SHARP**SERVICE MANUAL
SERVICE-ANLEITUNG****SUPPLEMENT**

**DLP PROJECTOR
DLP PROJEKTOR****MODELS
MODELLE****XV-Z9000U/E**

- The PC interface board programs have been updated as from the January 2002 production in order to improve the lip synchronization function.
- This SUPPLEMENT MANUAL discusses the program updating procedure. For to-be-reprogrammed units from users, first check the programs' version and then take their proper steps.

■ Modifications on the PC interface board

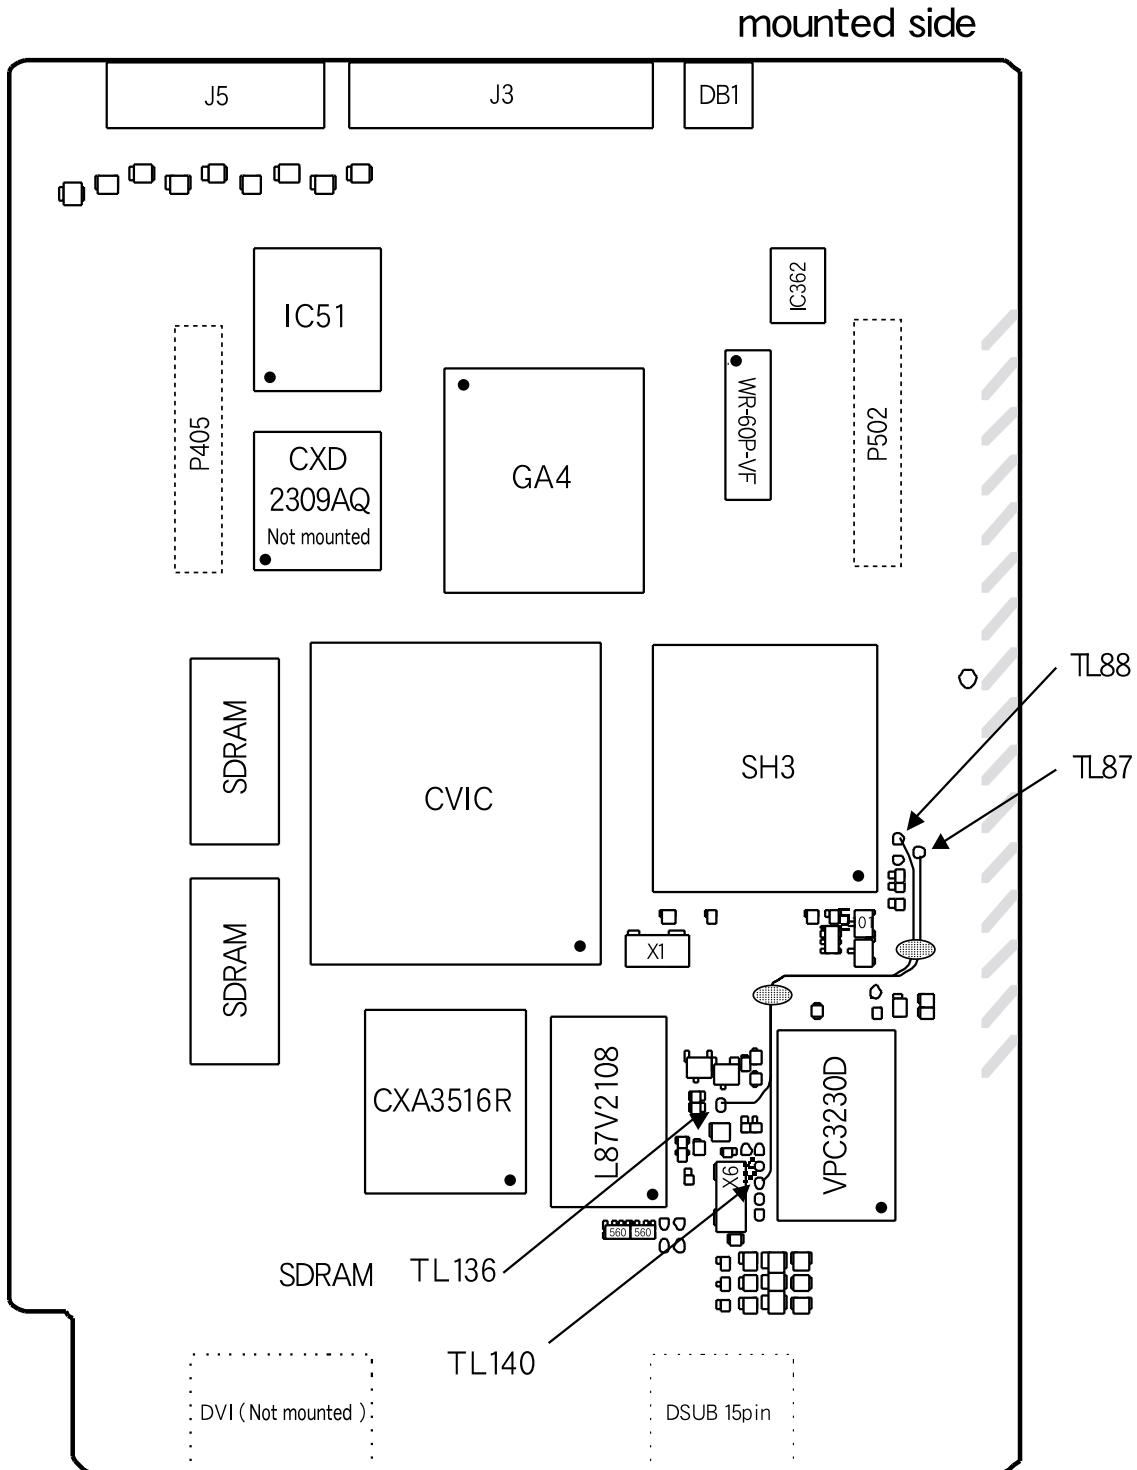
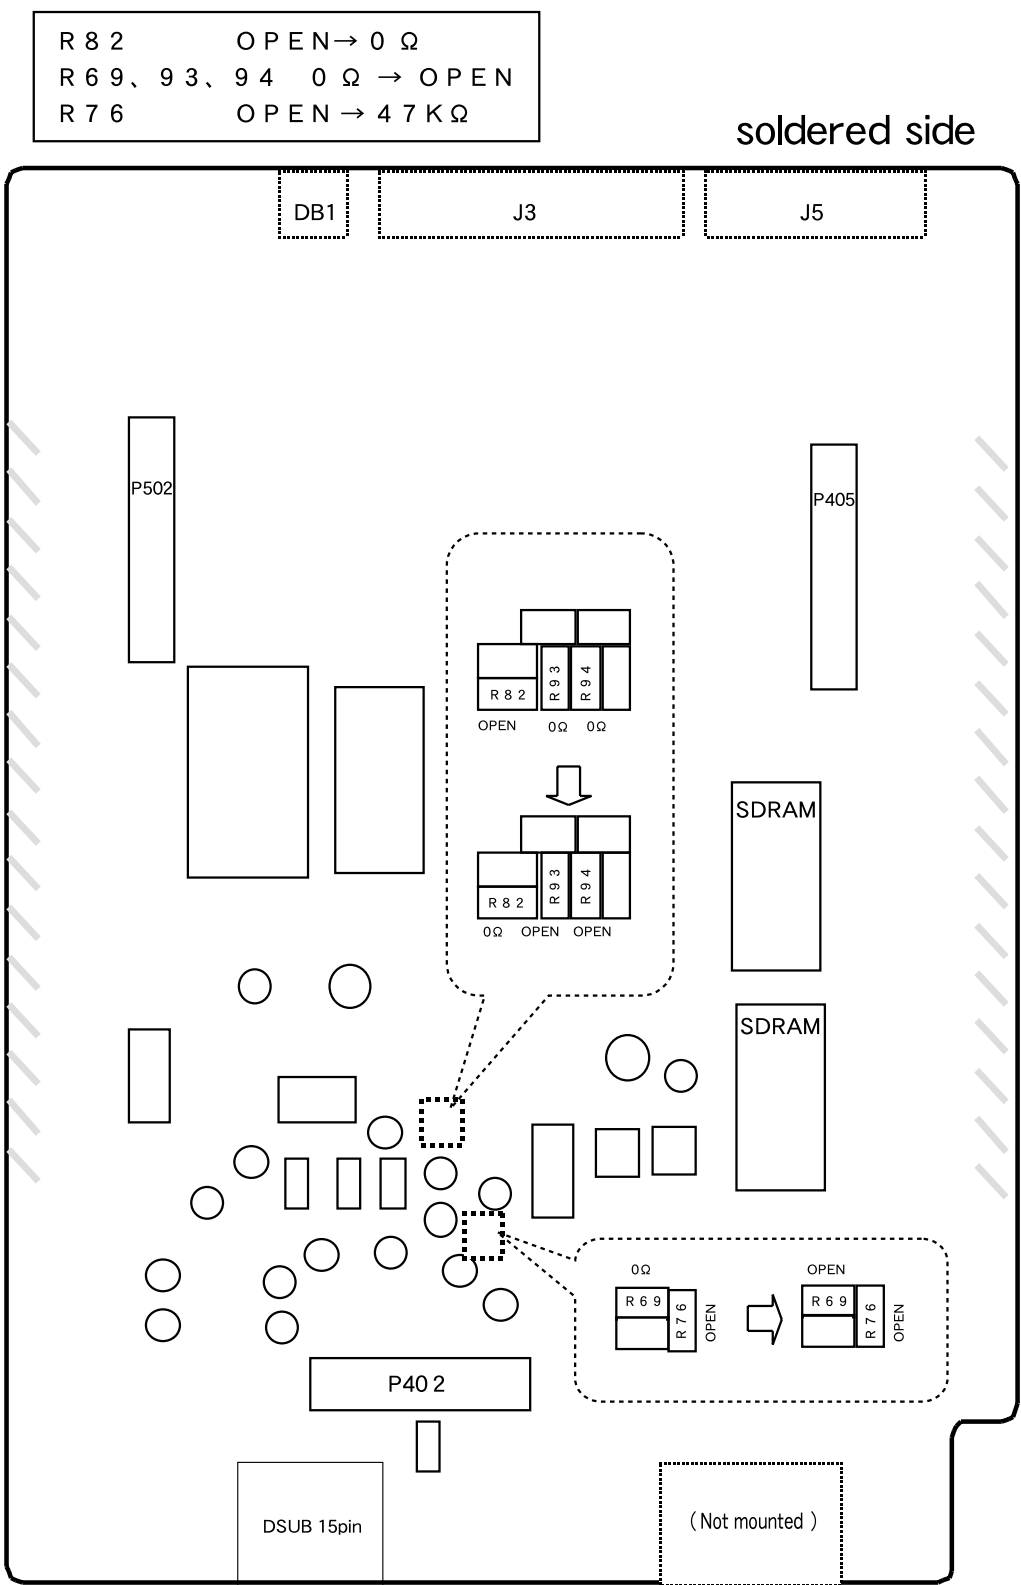
Connect one jumper between TL88 and TL136 and the other between TL87 and TL140. Apply adhesive to the specified points to secure the jumpers. Refer to the attachment file "0051 Modifications".

R82: Not mounted → 0 ohm

R69, R93 and R94: 0 ohm → abolished

R76: Not mounted → 47 ohms

Connect one jumper between TL88 and TL136 and the other jumper between TL87 and TL140. Apply adhesive to the two points indicated above.
